ORIGINAL ISSUE:		
08/15/18		
REVISIONS:		
No.	Description	Date
1	EARTHWORK PERMIT	9/28/18
2	EARTHWORK PERMIT AMENDMENT #1	11/01/18
3	ASI #3	01/10/19
4	CONSTRUCTION DOCUMENTS	02/28/19
5	ASI #5	05/10/19
6	ASI #7	06/14/19
7	ASI #10	08/30/19

BCS Phase 3 Housing

FDP DIMENSIONED SITE PLAN

C3.0

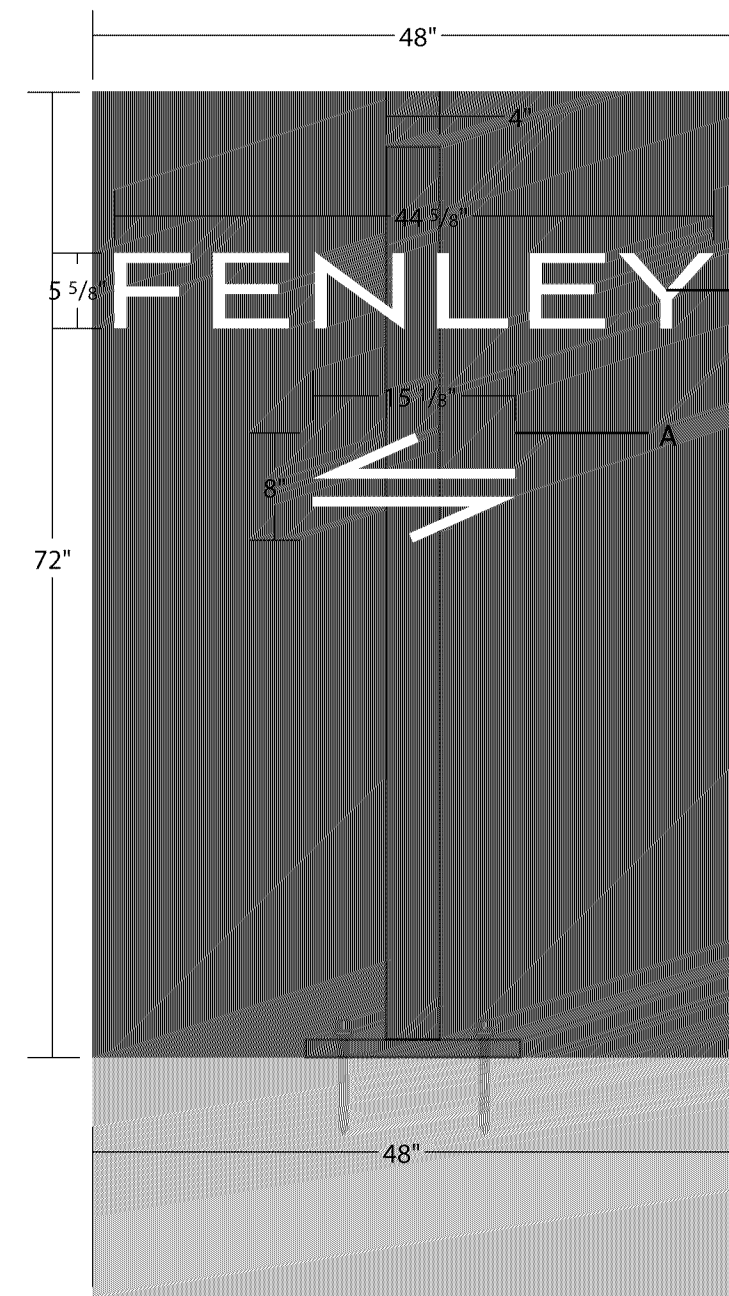
Orientate so that the sitting area is adjacent to the north-south sidewalk and the tall Fenley sign component is furthest east from the roadway (to maximize sightlines of vehicles exiting the site).
